NED-85-444
1766N

May 30, 1985

NRC DOCKETS 50-321, 50-366
OPERATING LICENSES DPR-57, NPF-5
EDWIN I. HATCH NUCLEAR PLANT UNITS 1, 2
SUPPLEMENTAL INFORMATION ON SEISMIC DESIGN ISSUES

DRAFT

FIGURE 3.7A-22

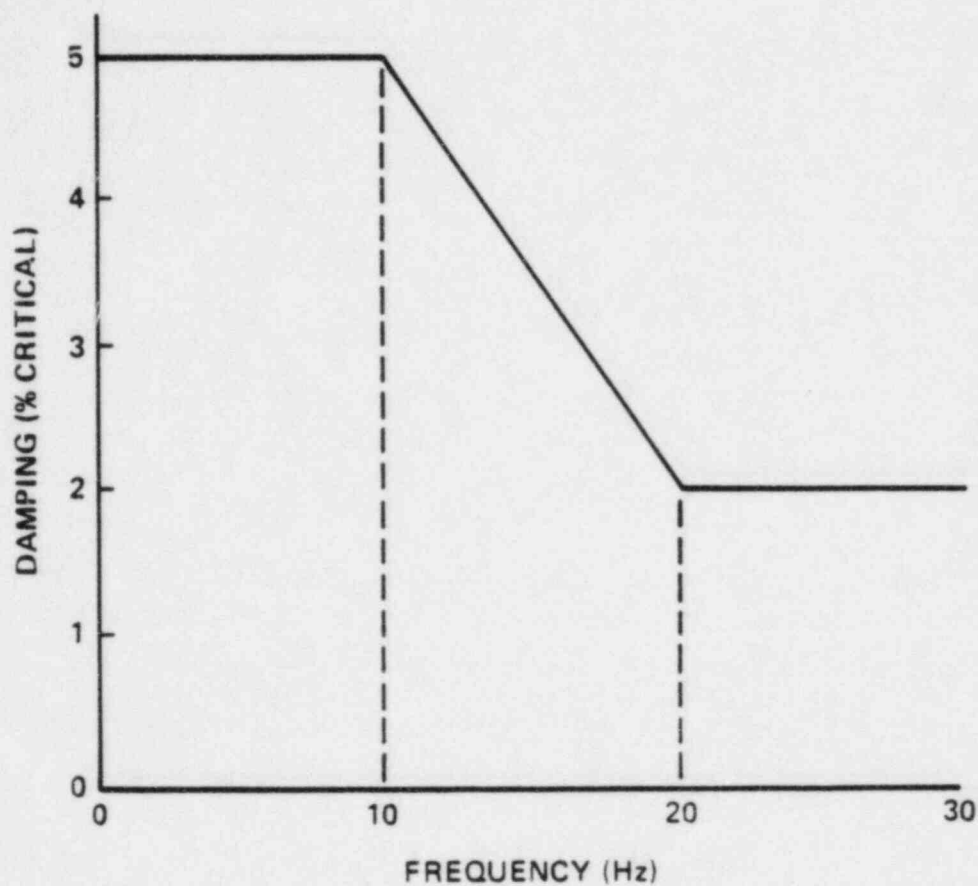
The seismic inputs to the original OBE and DBE piping systems analyses were defined using the 0.5-percent and 1.0-percent damped FRS, respectively. As of April 4, 1985, damping per figure 3.7A-22 is used in response spectrum analyses performed for all new and replacement systems and load reconciliation work. If as a result of using these damping values, piping supports are removed, modified, or eliminated, the expected

1. Applicable to both OBE and DBE, independent of pipe diameter.
2. As of April 4, 1985, damping per this figure is used for all new and replacement systems and load reconciliation work.

FIGURE 3.7A-23

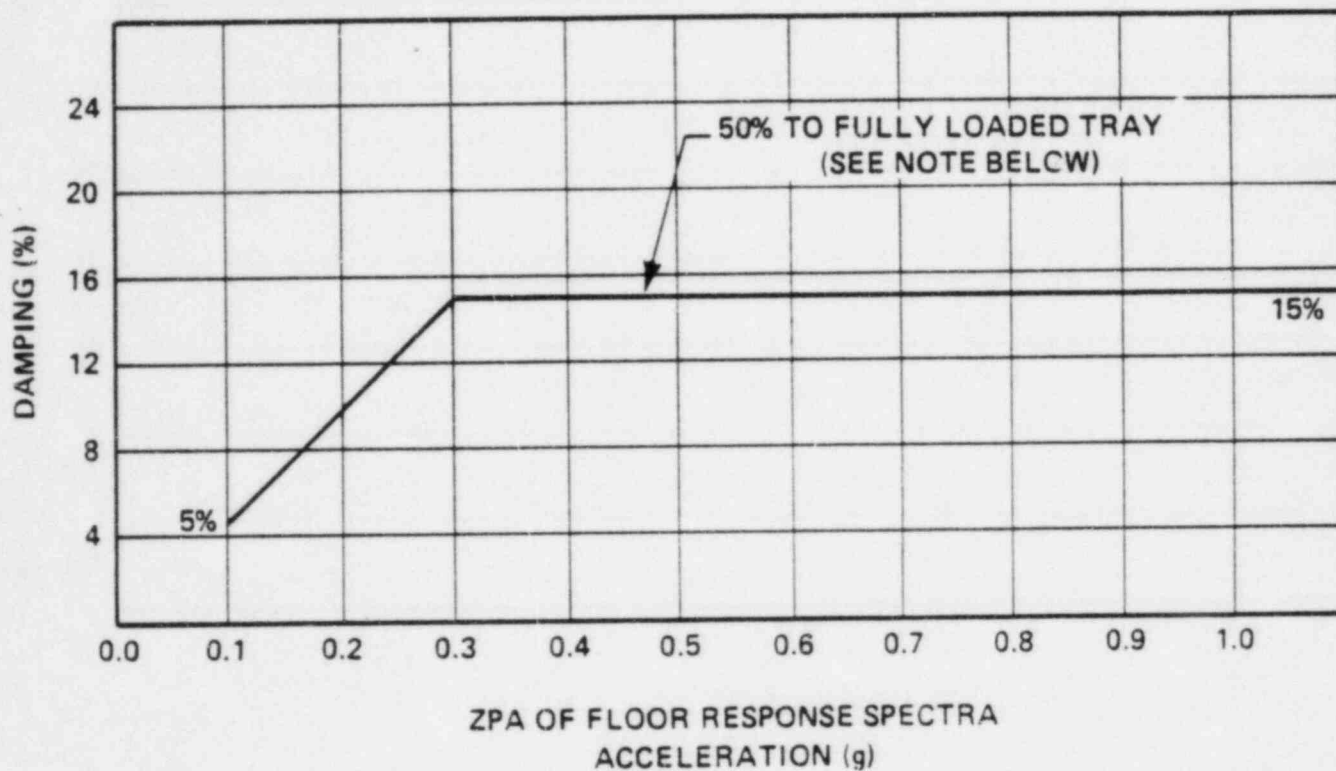
In the original cable tray support analyses, the applicable damping values were established, based upon the supports type of construction, using the values specified in table 3.7A-1. As of April 4, 1985, damping per figure 3.7A-23 is used for all new and replacement systems and load reconciliation work. The damping criteria specified in figure 3.7A-23 provide a conservative estimate of damping for cable tray supports based upon a test program. (6)

1. For unloaded tray, use damping values specified in Table 3.7A-1 for steel structures. For tray loaded less than 50% linear, interpolation is used to determine the applicable design damping value.
2. As of April 4, 1985, damping per this figure is used for all new and replacement systems and load reconciliation work.

FIGURE 12.3-2

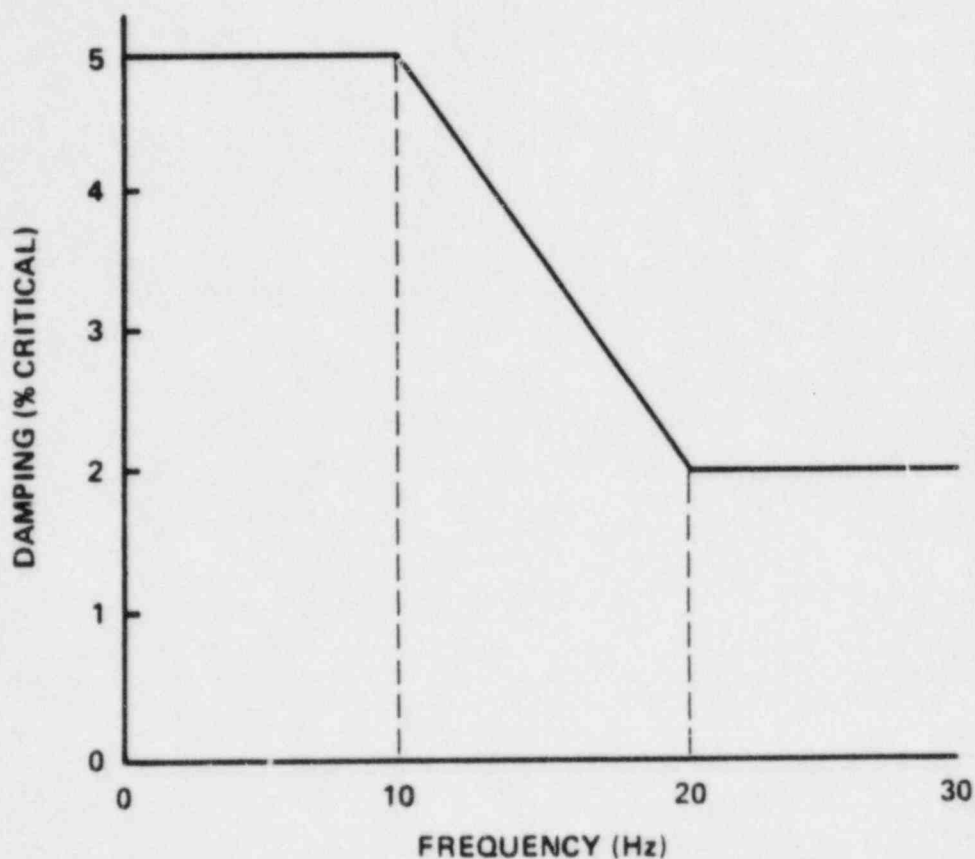
The seismic inputs to the original OBE and DBE piping system analyses were defined using the 0.5-percent and 1.0-percent damped floor response spectra, respectively. As of April 4, 1985, damping per figure 12.3-2 is used in response spectrum analyses performed for all new and replacement systems and load reconciliation work. If, as a result of using these damping values, piping supports are moved, modified, or eliminated, the expected increased piping displacements due to greater piping flexibility will be checked to assure that they can be accommodated and that there will be no adverse interaction with adjacent structures, components, and equipment. The damping criteria established by this figure are consistent with the frequency-dependent approach established by the Pressure Vessel Research Council Technical Committee on Piping Systems.⁽⁴⁾

- NOTES: 1. Applicable to both OBE and DBE, independent of pipe diameter.
2. As of April 4, 1985, damping per this figure is used for all new and replacement systems and load reconciliation work.

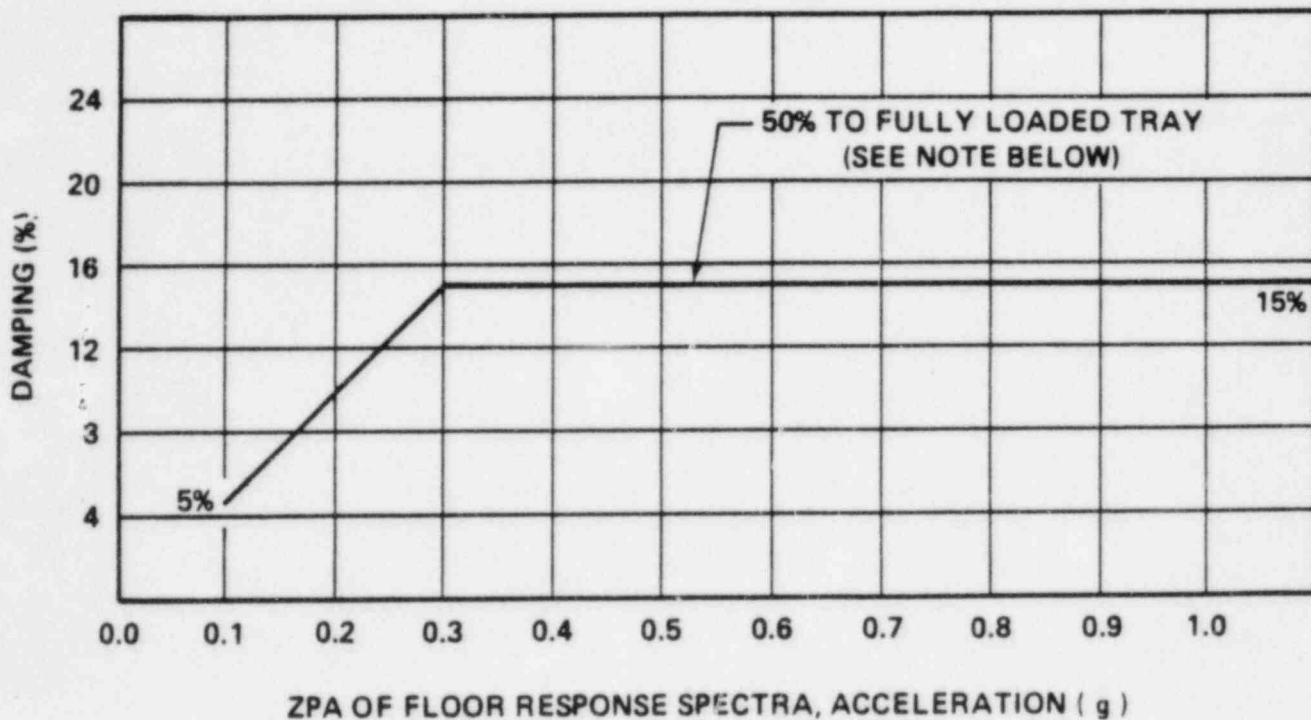
In the original cable tray support analyses, the applicable damping values were established, based upon the supports' type of construction, using the values specified in table 12.3-2. As of April 4, 1985, damping per figure 12.3-3 is used for all new and replacement systems and load reconciliation work. The damping criteria specified in figure 12.3-3 provide a conservative estimate of damping for cable tray supports based on a test program.⁽⁵⁾

- NOTES: 1. For unloaded tray, use damping values specified in Table 12.3-2 for steel structures. For tray loaded less than 50%, linear interpolation is used to determine the applicable design damping value.
2. As of April 4, 1985, damping per this figure is used for all new and replacement systems and load reconciliation work.
